Model Error Resolution Document

INITIATION

| 4. Document Identifier: MDL-WIS-PA-000005 REV 00 and AD 01 | 5. Document Title: Total System Performance Assessment Model/Analysis for the License Application | |

Figure 7.7.3-3[a]. TSPA-LA Mean Annual Dose for Major Radionuclides for the Combined Early Failure and Nominal Scenario Classes

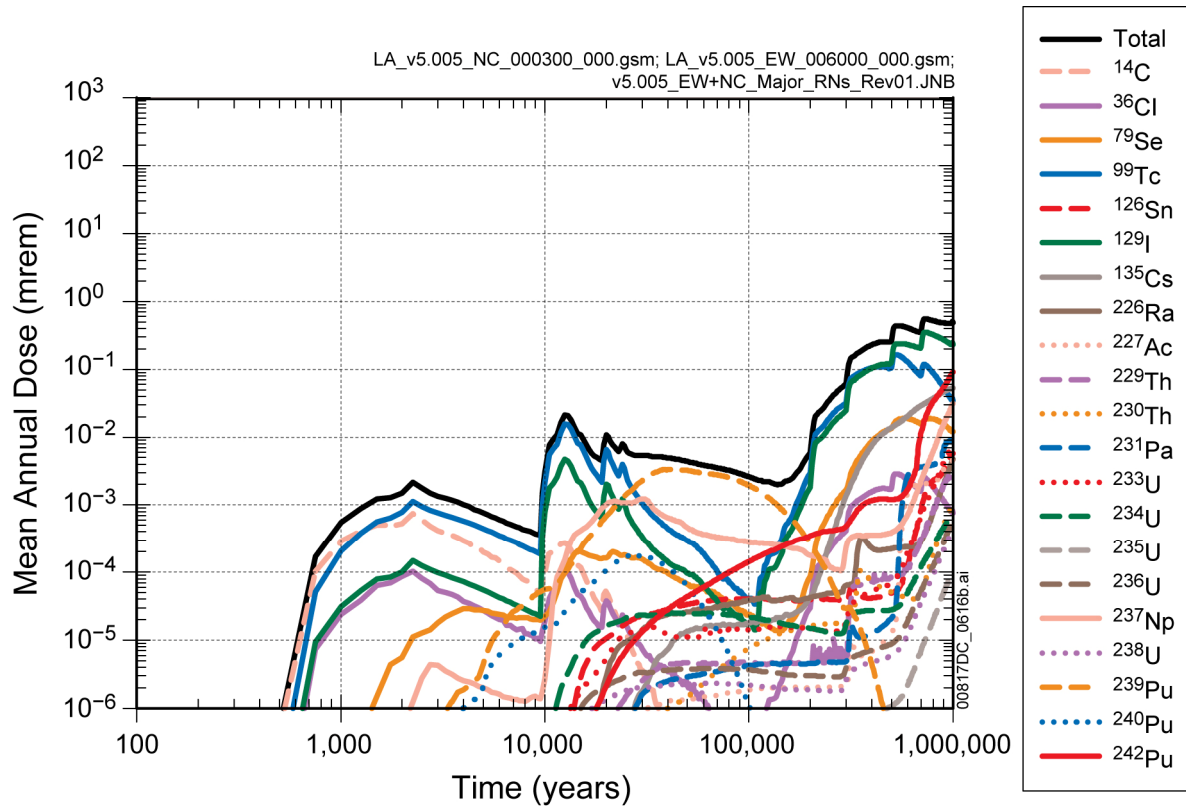
Replace Figure 7.7.3-3[a] (p. F7.7-128[a]) with the first figure shown in Attachment 2. The corrected figure is included in a new output DTN MO0805TSPACPLT.000 [DIRS 185506].

Figure 7.7.3-3. TSPA-LA Mean Annual Dose for Major Radionuclides for the Combined Early Failure and Nominal Scenario Classes

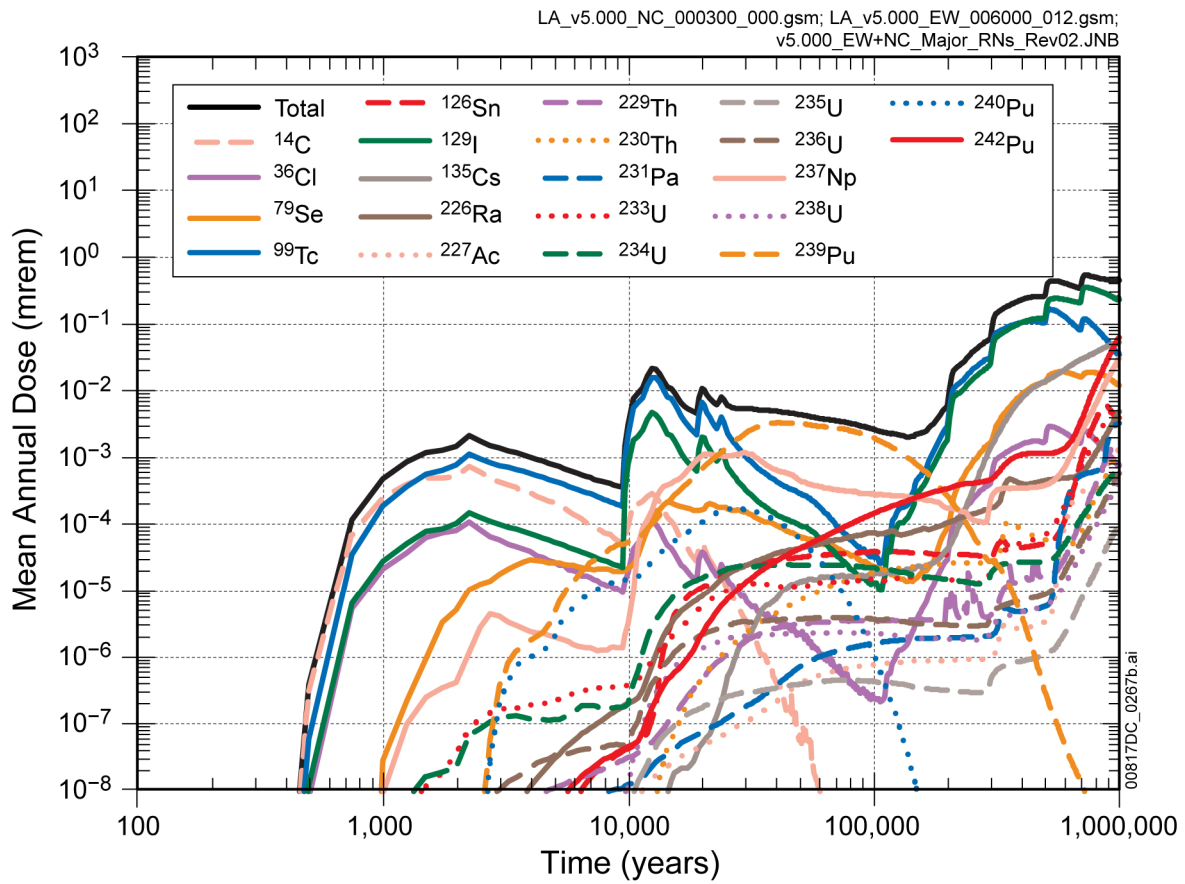
Replace Figure 7.7.3-3 with the 2nd figure shown in Attachment 2. The corrected figure is included in a new output DTN MO0805TSPACPLT.000 [DIRS 185506].
